UNITED STATES PATENT AND TRADEMARK OFFICE

APPLICATION NO.	FILING DATE	FIRST NAMED INVENTOR	ATTORNEY DOCKET NO.	CONFIRMATION NO.
10/826,397	04/19/2004	James Durham	H311030USCOM	9914

Office Action Summary	Application No.	Applicant(s)	
	10/826,397	DURHAM, JAMES	
	Examiner	Art Unit	
	Justin M. Larson	3782

DETAILED ACTION

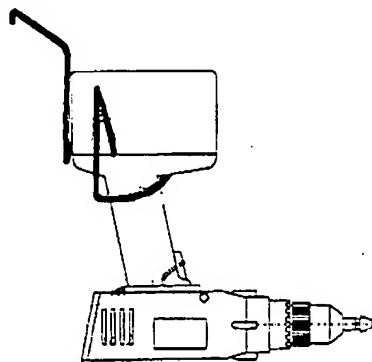
Regarding the manner in which a drill is supported by the holder, Estabaya teaches that the drill is placed in the holder such that the handle extends downwardly through the base until the battery compartment (BH) catches within the bight of the base. It would have been obvious to one having ordinary skill in the art at the time the invention was made to place a drill in the holder of Viio such that the handle of the drill extended downwardly through the base until the battery compartment caught within the bight of the base, as taught by Estabaya, in order to effectively support the drill within the holder. Examiner is of the position that when the battery housing of the drill becomes caught in the bight of Viio, it would certainly engage the upright portions of the holder. The battery housing is larger than the U-shape of the bight and would therefore contact any vertical structure protruding directly vertical from the U-shaped bight, such as the upright portions of the holder.

Applicant has asserted that it is not clear how the device of Viio could be used to hold a drill of the kind specified in claim 2. Examiner presents the following figure in an attempt to more clearly illustrate the use of the Viio device based on the teachings of Estabaya as set forth in paragraph #2 above.
